SERVICE BULLETIN REVISION NOTICE

ENGINE INDICATING — EXHAUST GAS TEMPERATURE (EGT) WIRING HARNESS AND
JUNCTION BOX ASSEMBLY — REPLACE WITH THERMOCOUPLE WIRING HARNESS
ASSEMBLY

Turbojet Engine Service Bulletin No. V2500-ENG-77-0015 Revision No. 1 dated August 3, 2017.

ENGINE INDICATING — EXHAUST GAS TEMPERATURE (EGT) WIRING HARNESS
AND JUNCTION BOX ASSEMBLY — REPLACE WITH THERMOCOUPLE
WIRING HARNESS ASSEMBLY

REMOVAL OF WIRING HARNESS AND BRACKET ASSEMBLY
FIGURE 6, SHEET 2

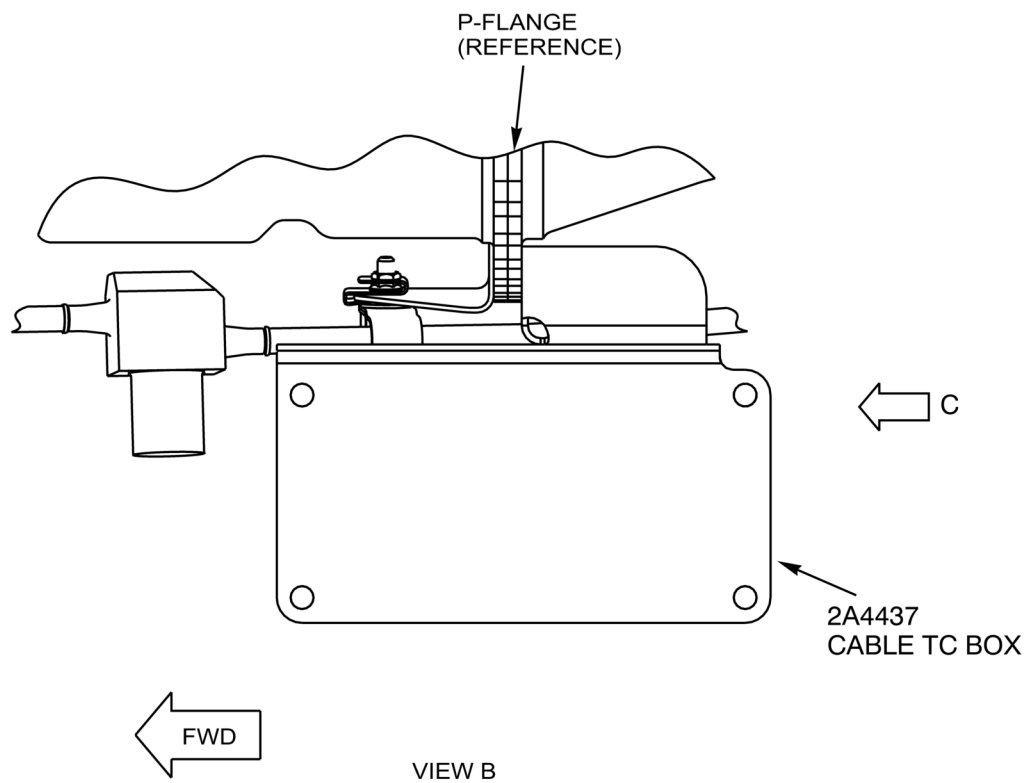
1. Remove the Cable TC Box, PN 2A4337 per Reference 6, Aircraft Maintenance Manual TASK 77-21-43-000-010-B. See Figure 6, Sheet 1 and Sheet 2.

REMOVAL OF WIRING HARNESS AND BRACKET ASSEMBLY
FIGURE 6, SHEET 3

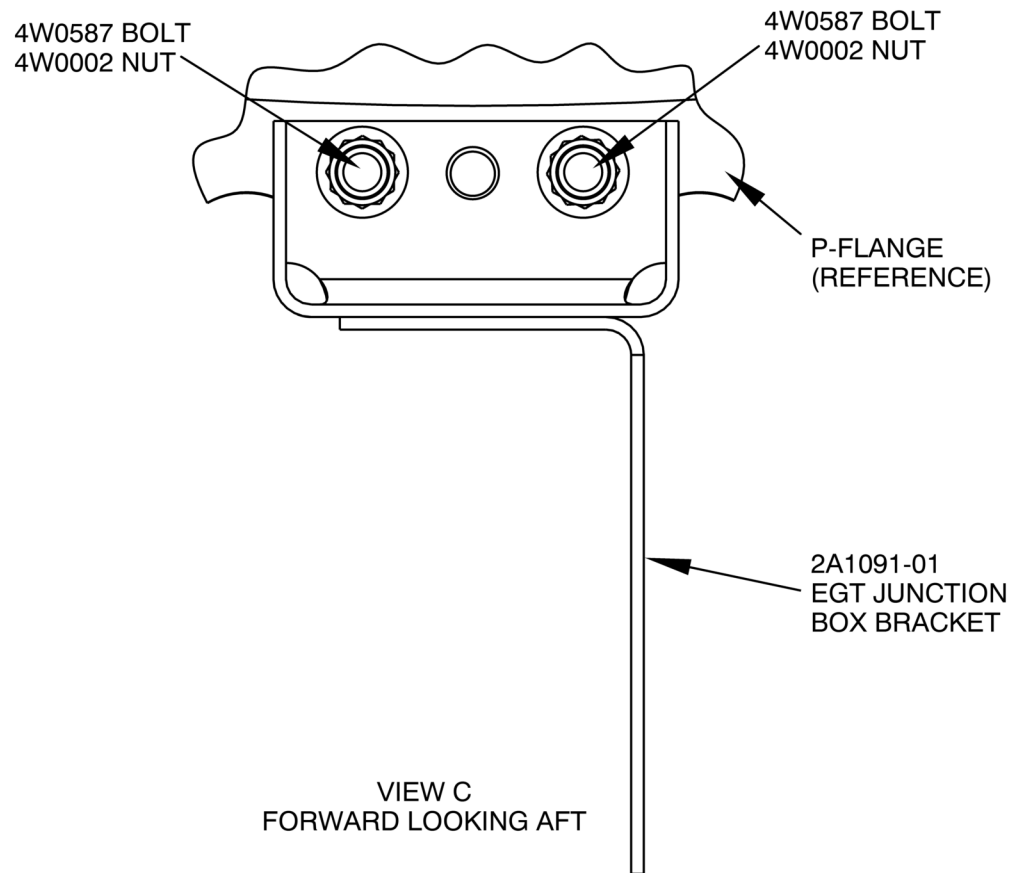
- A. Remove and retain the two Bolts, PN 4W0587 and two Nuts, PN 4W0002 that attach the bracket to the engine at the P-flange holes 57 and 58. See Figure 6, Sheet 3.
- B. Discard this bracket and make it unserviceable in an acceptable manner which is described in Reference 11, FAA - Order: 8120.11 "Disposition of scrap or salvageable aircraft parts and materials", dated 2/12/96.

ACC PERISEAL CONNECTOR LOCATION
FIGURE 7

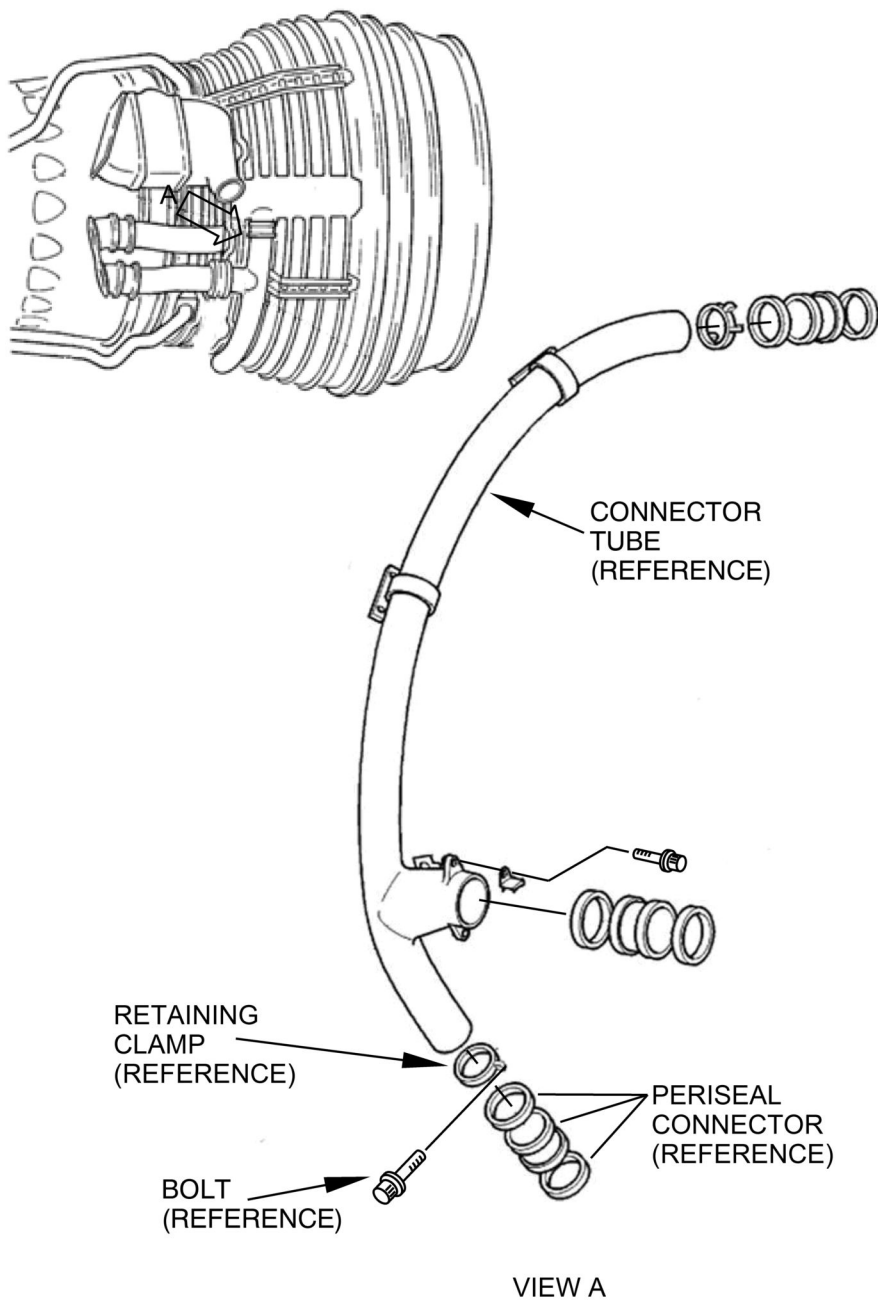
5. Move the Active Clearance Control (ACC) periseal housing. See Figure 7.

- C. Lower Harness Core Assembly, PN 6A5878, through gap created and remove from engine.
6. Assemble the ACC periseal housing. See Figure 7.
- A. Feed Wiring Harness Thermocouple Assy, PN 2A4524 at harness marked location through periseal gap.

- B. Move periseal connector on lower ACC tube to the original position to cover the opening.
 - C. Ensure that the pin of the retaining clamp engages in the location hole in the ACC tube.

- D. Ensure that the two periseals are correctly seated in the U-slots of the periseal connector.
 - E. Torque the bolt on the retaining clamp to the periseal connector to between 36 – 45 lbf-in (4.1 – 5.1 Nm). Reference 3, Standard Practices and Processes, TASK 70-41-02-410-501.

INSTALLATION OF WIRING HARNESS BRACKET ASSEMBLY
FIGURE 8, SHEET 1

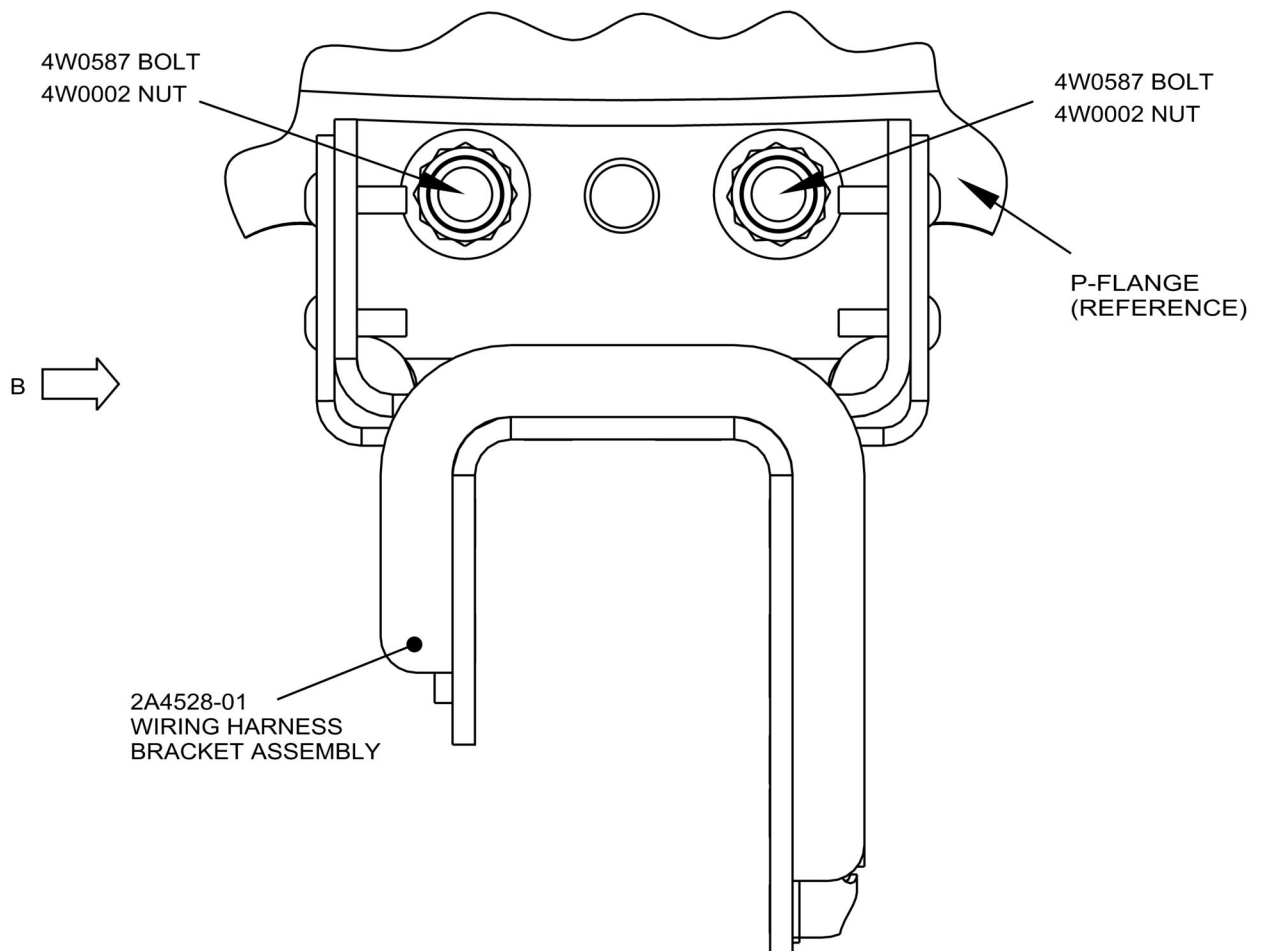
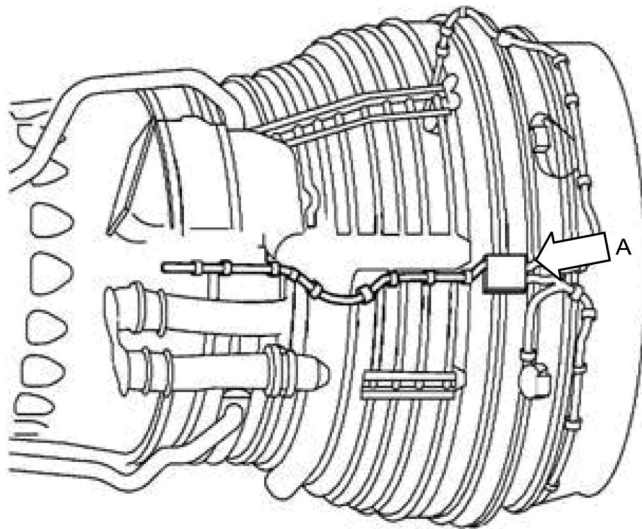
7. Install the Wiring Harness Bracket Assembly, PN 2A4528-01 as follows;
- A. Install the Wiring Harness Bracket Assembly, PN 2A4528-01 on the AFT side of the P-Flange at holes 57 and 58 using two Bolts, PN 4W0587 and two Nuts, PN 4W0002. See Figure 8, Sheet 1.

- B. Torque the bolts to between 85 – 105 lbf-in (9.60 – 11.86 Nm). Reference 3, Standard Practices and Processes, TASK 70-41-02-410-501.
8. Install the new EGT harness to the wiring harness bracket assembly at the P-flange.

INSTALLATION OF WIRING HARNESS BRACKET ASSEMBLY
FIGURE 8, SHEET 2

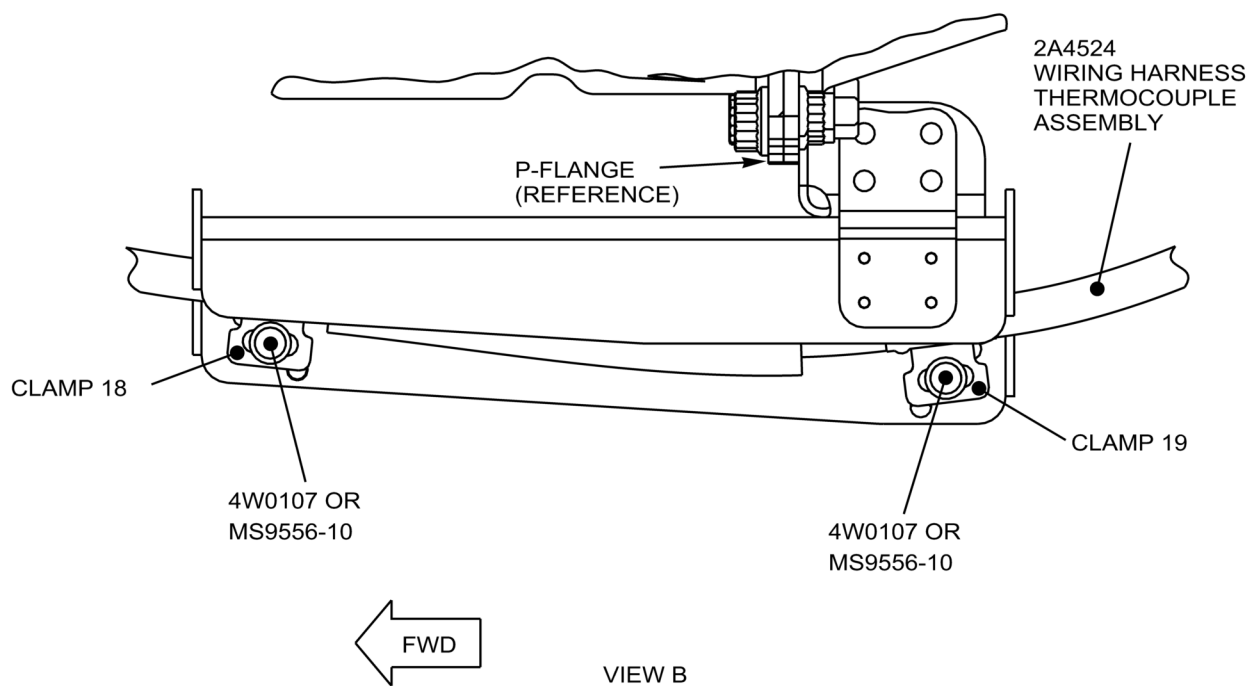
- A. Install the Wiring Harness Thermocouple Assy, PN 2A4524 integral clamps 18 and 19 to the Wiring Harness Bracket Assembly, PN 2A4528-01 on the P-flange using two Bolts, PN 4W0107 or PN MS9556-10. See Figure 8, Sheet 2.

- B. Torque the bolts to between 36 – 45 lbf-in (4.1 – 5.1 Nm). Reference 3, Standard Practices and Processes, TASK 70-41-02-410-501.
9. Install the Wiring Harness Thermocouple Assy, PN 2A4524 to the flange brackets AFT of the wiring harness bracket assembly. Reference 6, Aircraft Maintenance Manual, TASK 77-21-43-400-804-B.

AFT WIRING HARNESS CLIP LOCATIONS
FIGURE 9, SHEET 1

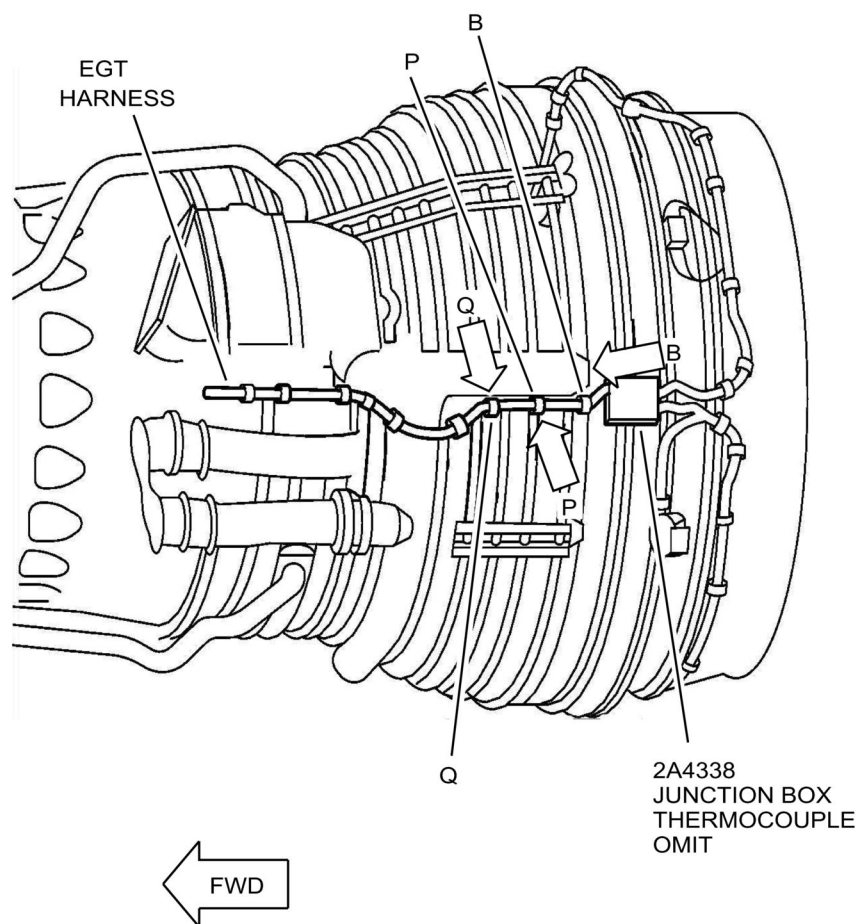
10. Install the new Wiring Harness Thermocouple Assy, PN 2A4524 forward of the supporting bracket replace (10) Clamps, PN TA025022-05 with (10) Clamps, PN TA025022-06 with the exception of the following steps. Reference 6, Aircraft Maintenance Manual, TASK 77-21-43-400-804-B.

- A. Install the harness at Position “B” except omit the Clamp, PN TA025022-05. See Figure 9, Sheet 1 and Sheet 2.
 - B. Install the harness at Position “P” except omit the Clamp, PN TA025022-05. See Figure 9, Sheet 1 and Sheet 2.

- C. Install the harness at Position “Q” except omit the Clamp, PN TA025022-05. See Figure 9, Sheet 1 and Sheet 2.
 - D. Install the harness at Position “J” except omit the Clamp, PN TA025022-05. See Figure 10, Sheet 1 and Sheet 2.
 - E. Install the harness at Position “K” except omit the Clamp, PN TA025022-05. See Figure 10, Sheet 1 and Sheet 2.
 - F. Install the harness at Position “M” except omit the Clamp, PN TA025022-05. See Figure 10, Sheet 1 and Sheet 2.
 - G. Install the harness at Position “N” except omit the Clamp, PN TA025022-05. See Figure 10, Sheet 1 and Sheet 2.
11. Test Requirement
- A. Do an operational test of the FADEC, Reference 6, Aircraft Maintenance Manual, TASK 73-22-00-710-040, and a check on the CFDS to make sure no fault is shown related to the EGT harness.
12. Recording Instructions
- A. A record of accomplishment is required.

FORWARD WIRING HARNESS CLIP LOCATIONS
FIGURE 10, SHEET 1

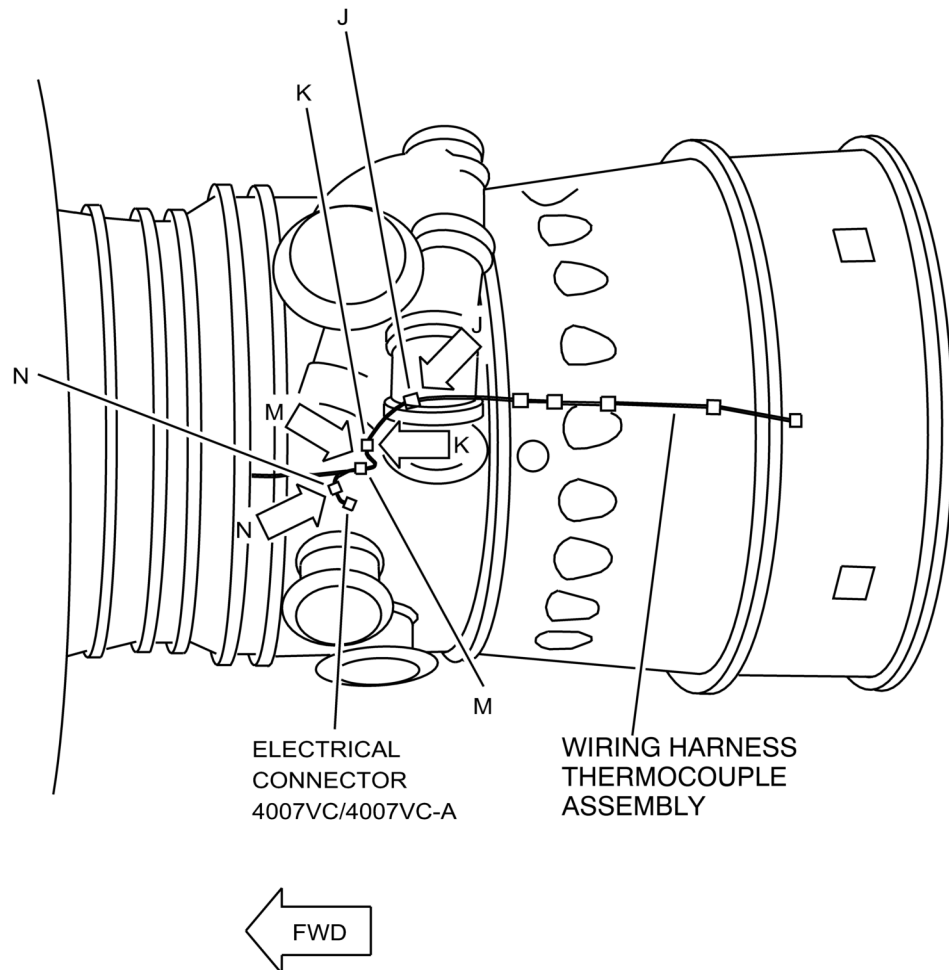
4. Inspect EEC Core Harness electrical connector 4007VC-A (which mates with EGT harness 4007VC). Examine the sockets (female contacts) per Reference 6, Aircraft Maintenance Manual, TASK 71-50-00-210-010. See Figure 10, Sheet 1.

- A. Examine sockets (contacts) for alignment and damage.
- B. Examine to confirm no contacts are pushed rearward into the connector face.
- C. Examine connector sockets for corrosion, deformation, distortion or discoloration by inserting a harness connector pin into each socket. Friction must be felt while inserting and removing the harness connector pin. Alternately, the Retention Test Tool HT210-16 may be used per Reference 6, Aircraft Maintenance Manual, TASK 70-71-21 Contact Replacement Procedure.
- D. Replace contacts as necessary per Reference 6, Aircraft Maintenance Manual, TASK 70-71-21 Contact Replacement Procedure.
